JOSEPH P. CARRARA & SONS, INC. LETTER OF TRANSMITTAL

DATE: January 23, 2014	JOB NO: 23411-013
ATTENTION: Mr. Brian Emmons *bemmons@tbuckcon.net*	
RE: Sand Hill Bridge No. 13	
VT 125 over Middlebury River	
Middlebury, VT	
Project No. RS 0174 (8)	
Transmittal #8	Precast Concrete

COPIES	DATE	NO.	DESCRIPTION
1	1/23/14	as noted	J. P. Carrara & Sons' Precast Framing and Individual Piece Detail Drawings for NEXT 28D Beams:
			"For Approval" Framing Drawings: F1 & F1.1
			"For Approval" Piece Detail Drawings: NB1, NB1.1, NB2, NB2.1, NB3, NB3.1, NB4, NB4.1,
			NB5, NB5.1, NBM1, & NBM2
1	1/23/14	-	JPC Lifting Loop Design Calculations for NEXT 28D Beams

A / F1.1 NEXT BEAM CLOSURE POUR DETAIL

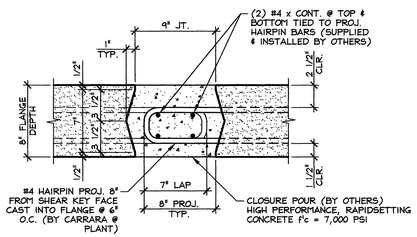
1. JPC proposes the use of the shear key shown in detail A/F1.1 to match JPC's existing steel siderail form for projecting hairpin bars.

B / F1.1 CURTAIN WALL CLOSURE POUR DETAILS

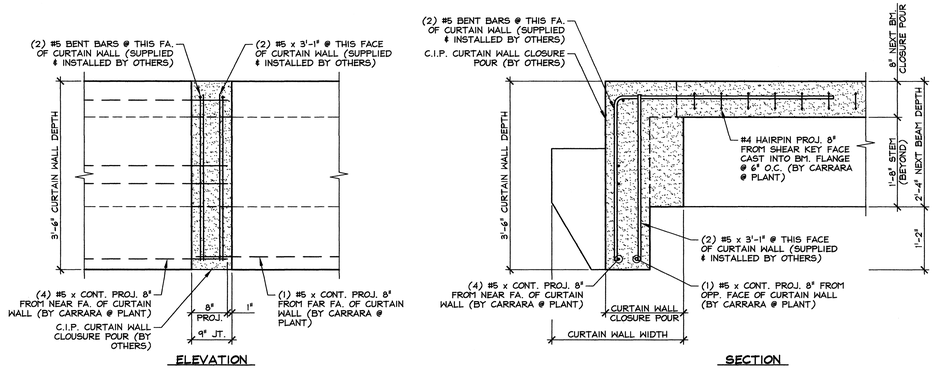
2. At curtain wall closure pours, (4) bars project from precast curtain wall on one side and only (1) on the other to otherwise avoid installation conflicts. Contract plans call for projecting bars to be alternating.

A NB1.1 PROJECTING STRAND & PROJECTING BAR BEND DETAIL

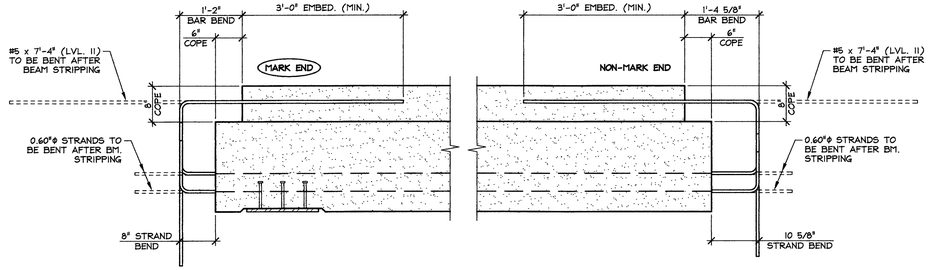
4. #5 x 7'4" projecting bars shall be bent and touched up in the plant prior to curtain wall fabrication, ref. A/NB1.1.

DWG. NO: NB2

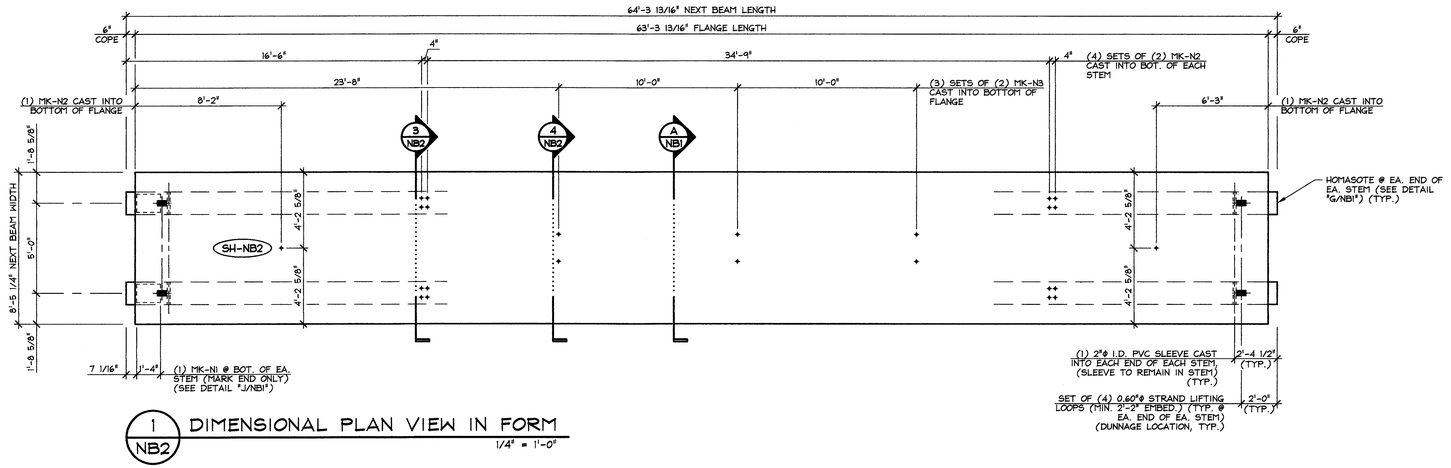
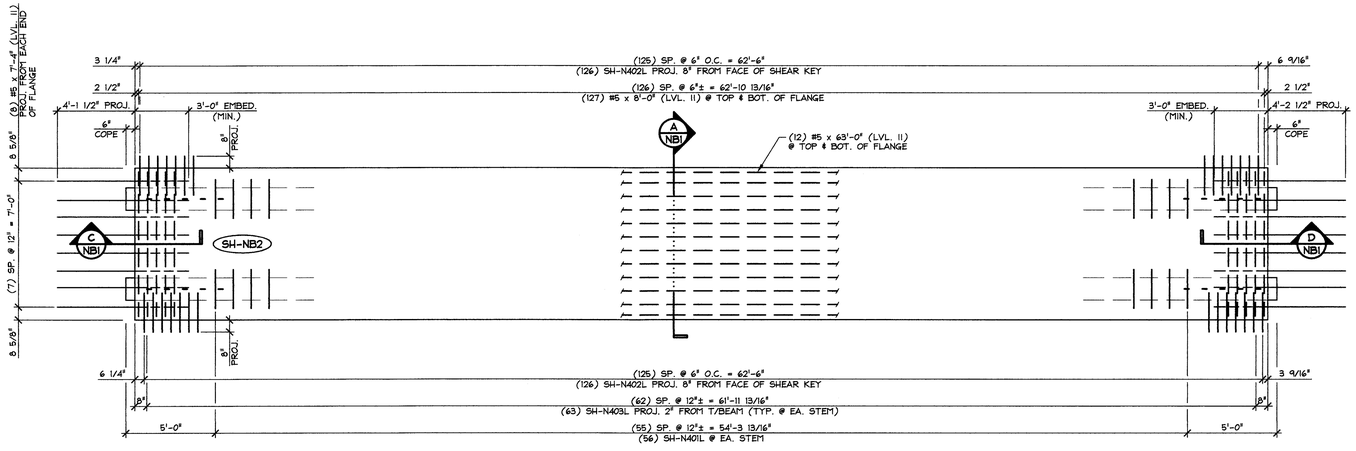
5. Please confirm the size and layout of inserts in beam SH-NB2 on drawing NB2 for waterline support and hoist inserts.

DATE: OCT. 9, 2013
SCALE: NOTED
CHKD: DFTM: B.L.
JOB NO: 23411-013
DWG. NO: NB5

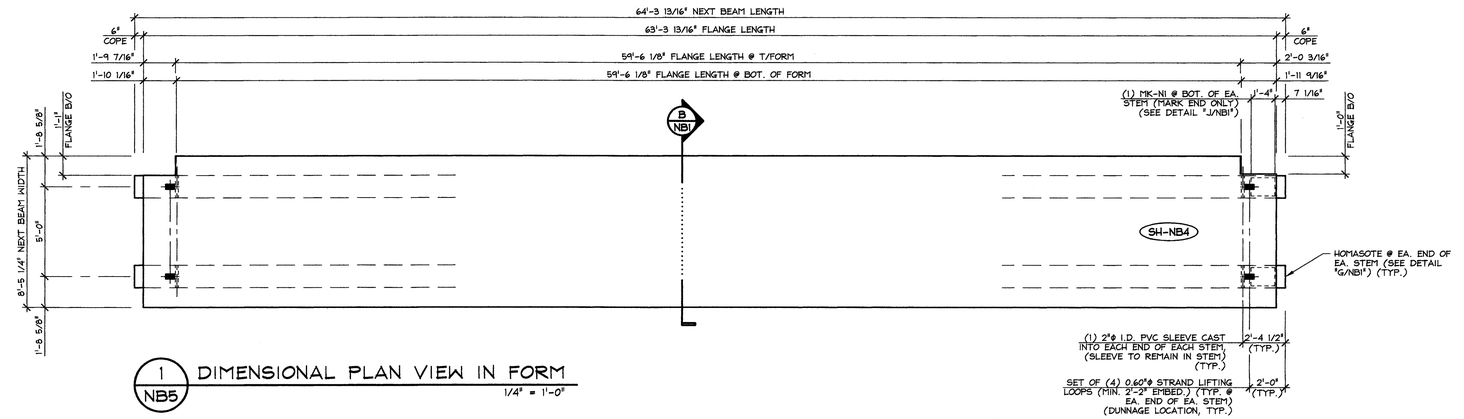
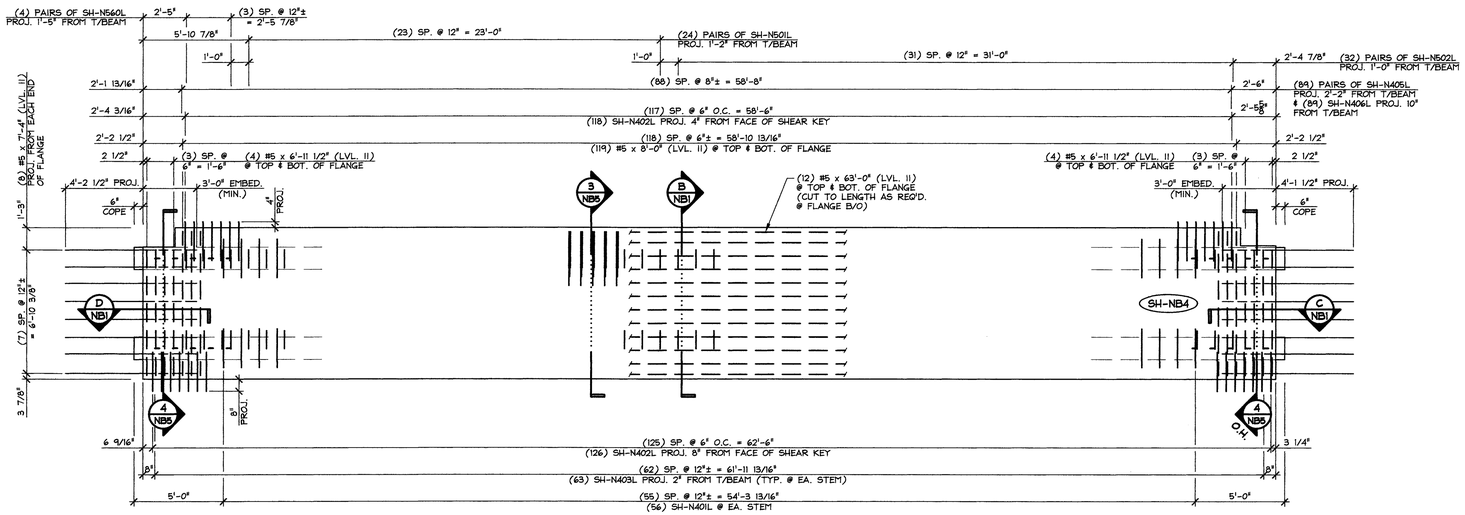
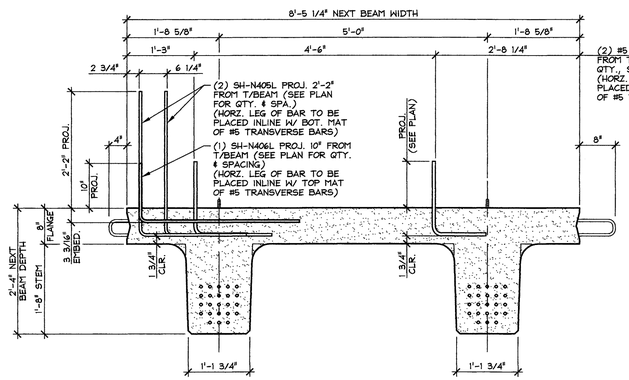
7. JPC proposes to use (3) different projecting lengths of #5 bars for CIP sidewalk to accommodate its profile which varies due to the thickness of the CIP which varies between 3 1/8" to 10 11/16" over the span of the beam, ref. drawing NB5.
